Wednesday 1 December, 2021

Major Projects Team
Warragamba Dam Raising Proposal
Department of Planning, Industry and Environment
Locked Bag 5022
Parramatta NSW 2124

Objection to the proposed raising of the Warragamba Dam wall (SSI-8441)

Figure 2. Relative contribution of different river catchments in a range of floods in the Hawkesbury-Nepean Valley

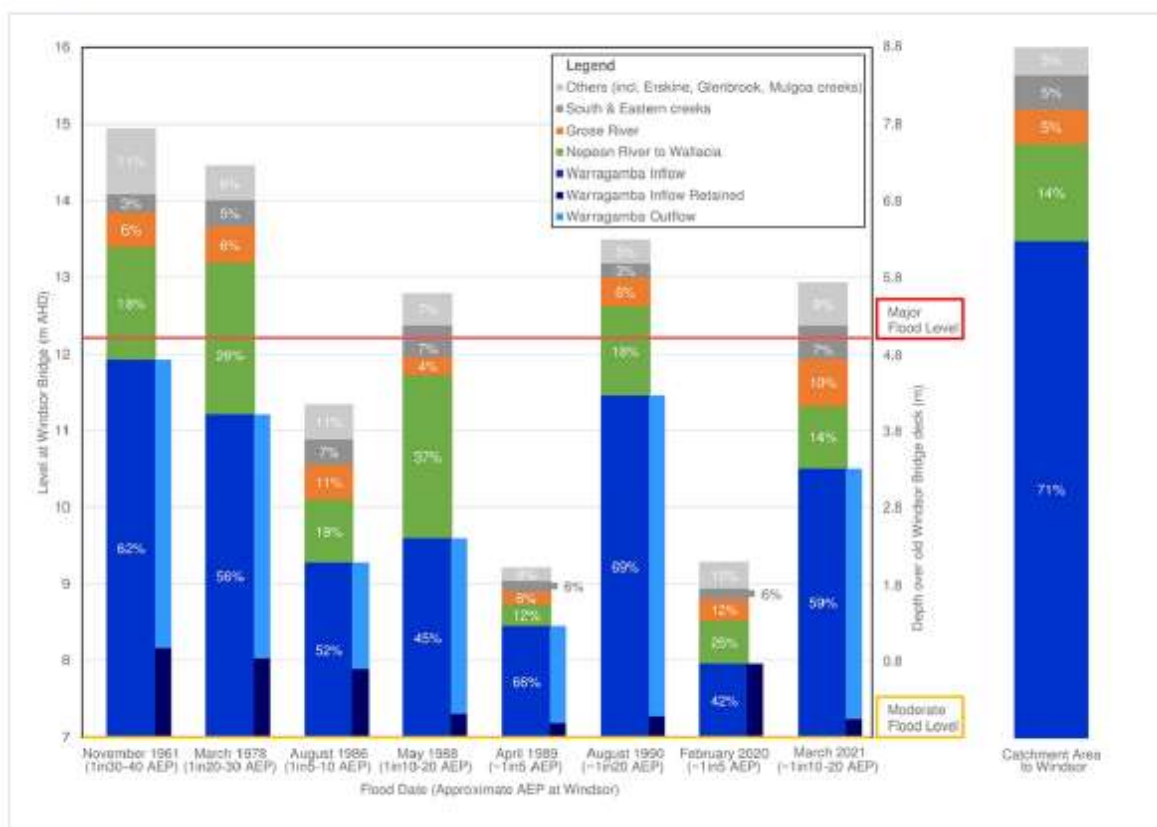
The EIS claims that ‘The large Warragamba Dam catchment historically contributes up to 70 percent of flows during flooding in the Hawkesbury-Nepean’ (see Figure 2 in the executive summary). This claim is misleading as it refers to **inflows** to the dam. Only outflows from the existing dam impact on flooding downstream, so the reference to 70 percent of flows during flooding is misleading.

The EIS narrative for Figure 2 should instead state that **outflows** from Warragamba Dam to have, on average, contributed slightly less than half of downstream floods (i.e. the light blue bars in Figure 2). In other words, providing additional flood mitigation by temporarily storing additional flood water behind Warragamba Dam over the World Heritage Area can only address half the floods. So, the proposed raising the dam wall can only be a half-measure.

Only the light blue bars showing Warragamba dam's outflows to downstream floods are relevant to the analysis of relative contributions from catchments (inflow-retained waters).
